CNL-16-137

Subject: **Watts Bar Nuclear Plant Units 1 and 2 - Response to Request for Additional Information Regarding Request to Revise Technical Specifications for Diesel Generator Completion Time Extension for Technical Specification 3.8.1, AC Sources – Operating (TAC Nos. MF7147 AND MF7148)**

Response To Request for Additional Information Regarding Request to Revise Technical Specifications for Diesel Generator Completion Time Extension for Technical Specification 3.8.1, AC Sources – Operating (TAC Nos. MF7147 AND MF7148) for Watts Bar Nuclear Plant Units 1 and 2

Figure 1
Watts Bar Nuclear Plant Example
Station Blackout with FLEX Diesel Generators

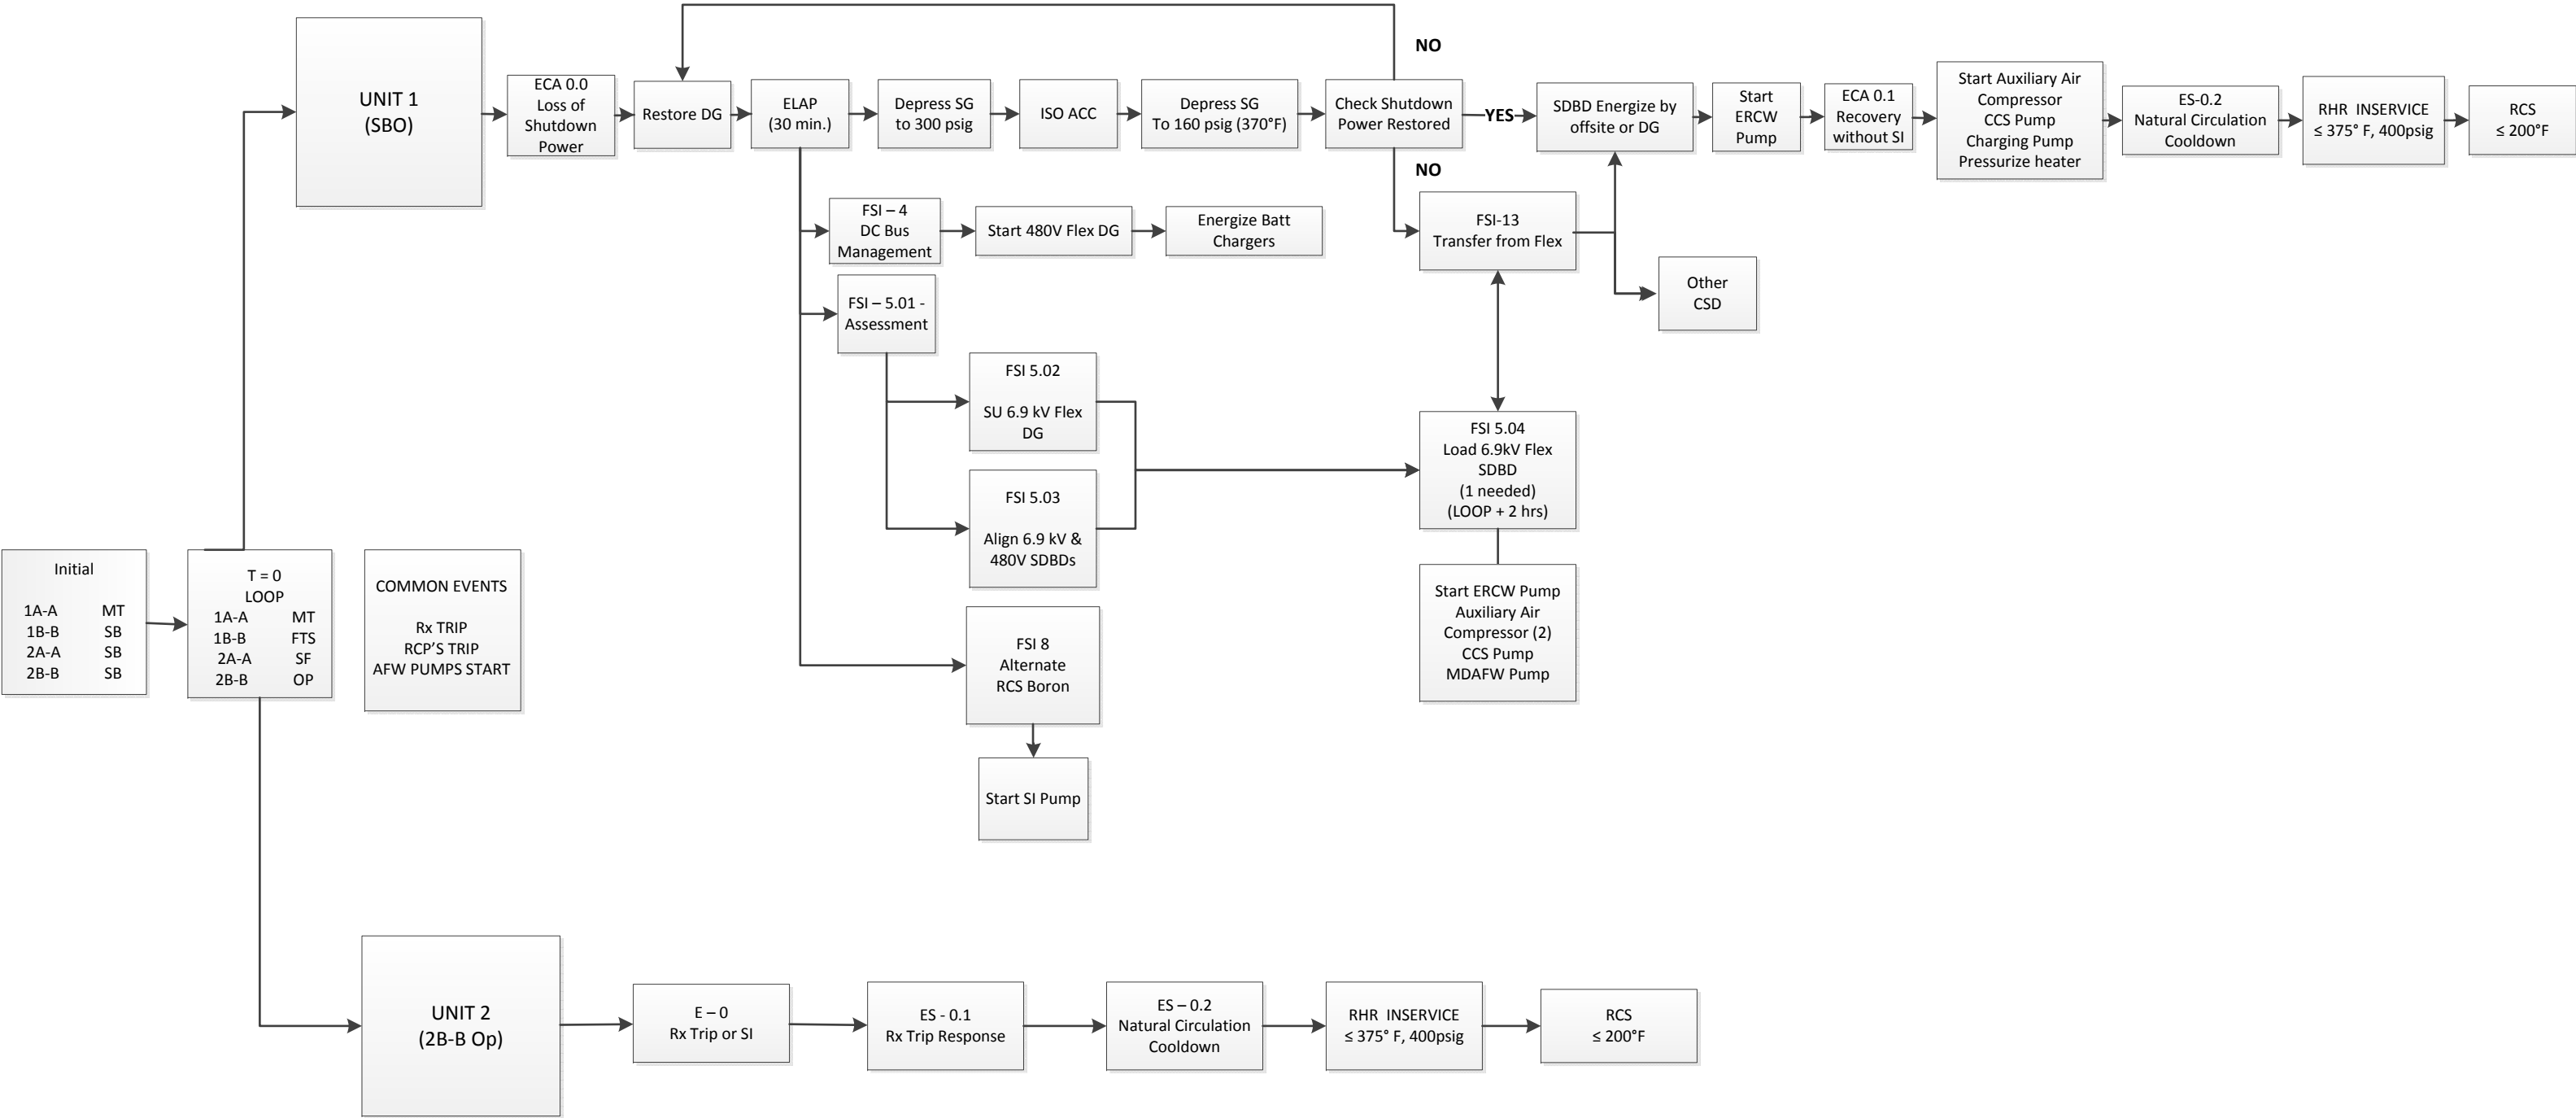
- a) Please explain the sequence of events of a LOOP (both Units) when Unit 1 DG 1A-A (or 1B-B) is under maintenance, the redundant DG 1B-B (or 1A-A) fails to start (SBO Unit 1) and a Unit 2 DG has a single failure.*
- b) Please explain if the response is also applicable for SBO in Unit 2 and single failure of a DG in Unit 1*
- c) According to the Watts Bar licensing basis, safe shutdown is considered as placing both units in a hot standby (Technical Specification MODE 3) condition and maintaining such a condition. However in view of proposed extended maintenance on one standby DG, BTP 8-8 recommends that the supplemental AC source, used to support extended CT, have the capacity and capability to bring the Unit to cold shutdown. Please confirm that one 6.9 kV FLEX DG coupled with one standby DG is adequate to place both units in cold shutdown and maintain cold shutdown conditions.”*

In the example shown in Figure 1, initially both units at WBN are at 100% power with DG 1A-A out-of-service for maintenance. The other DGs are operable and in a standby condition. As defined in NRC Request 3a, the event is initiated when a LOOP occurs; DG 1B-B fails to start, and DG 2A-A also fails to start as the single failure, leaving DG 2B-B as the only DG in operation. These failures result in WBN Unit 1 in a station blackout (SBO) condition with no offsite or onsite power available to the Unit 1 6.9 kV shutdown boards (SDBs) (1A-A and 1B-B). WBN Unit 2 DG 2B-B is powering 6.9 kV SDB 2B-B while the 2A-A 6.9 kV SDB is de-energized.

As stated in ECA-0.0, a recovery plan is needed after FLEX implementation is started to energize a shutdown board when a plant DG or offsite power has been made available. The flowpath outlined in Figure 1 would provide guidance on placing the unit in cold shutdown whether offsite power, DG power, or FLEX DG power is used.

Because this question results in WBN being in an SBO condition, Figure 1 and the response to NRC Request 3 can be referenced.

Figure 2

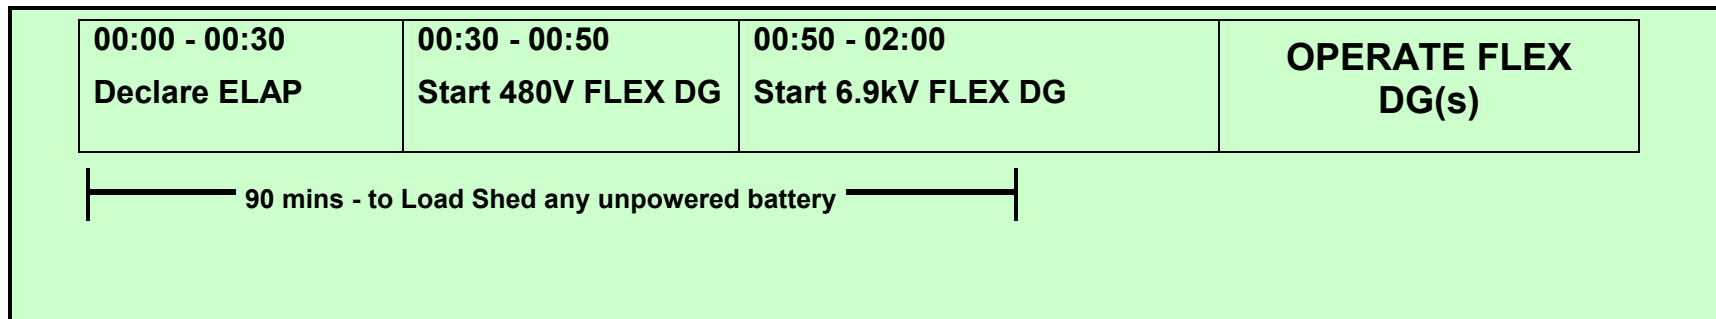
“Please provide details of DG loadings for the scenarios considered in question 5 above. In view of the differences in DG loadings, please indicate which case is the limiting case. Also, provide a time-line based on plant procedures, for connecting the proposed 6.9 kV FLEX DG to the associated safety-related bus/busses in the above scenarios.”

- a) Please confirm whether the 480 V FLEX DGs are part of the proposed extension request for DGs and will have the same requirements for testing and availability checks as the 6.9 kV FLEX DGs.*
- b) Assuming that it takes the proposed TS allowed time of 2 hours to establish the availability of the 6.9 kV FLEX DG, please provide a time line, using current plant procedures, for connecting the proposed 6.9 kV FLEX DG and the 480 V FLEX DG (if required) to each of the associated safety busses if an unplanned DG maintenance was being conducted and a LOOP event is experienced.*
- c) For the event postulated in item b) above, please confirm if the Unit with DG undergoing maintenance will first enter SBO procedures if the associated DG fails to start.”*

The loading for the FLEX DGs, as shown in Table 3-1 would be approximately the same for all alignments with exception of the alignment to the 6.9 kV SDB 1B-B because it would not have a CCS pump connected. In this case, the loading would be 265 kW less. The timeline, based on plant procedures, for connecting the proposed 6.9 kV FLEX DG to the associated safety-related busses is shown on Figure 2, approximately 2 hours.

- b) Figure 2 contains a pictorial display of the timeline. ECA-0.0 states that if power is not restored to a 6.9 kV SDB within 30 minutes an ELAP is declared and FSI-4 and FSI-5.01 are entered to manage the DC distribution system and FLEX strategies. FSI-4 starts the 480 V FLEX DG or, if they are not available, provides guidance on shedding loads on the batteries and alignment to the 6.9 kV FLEX DG. Estimated time for energizing the 6.9 kV SDB(s) with a 6.9 kV FLEX DG is 2 hours. Further information is provided in the response to NRC Request 3a.
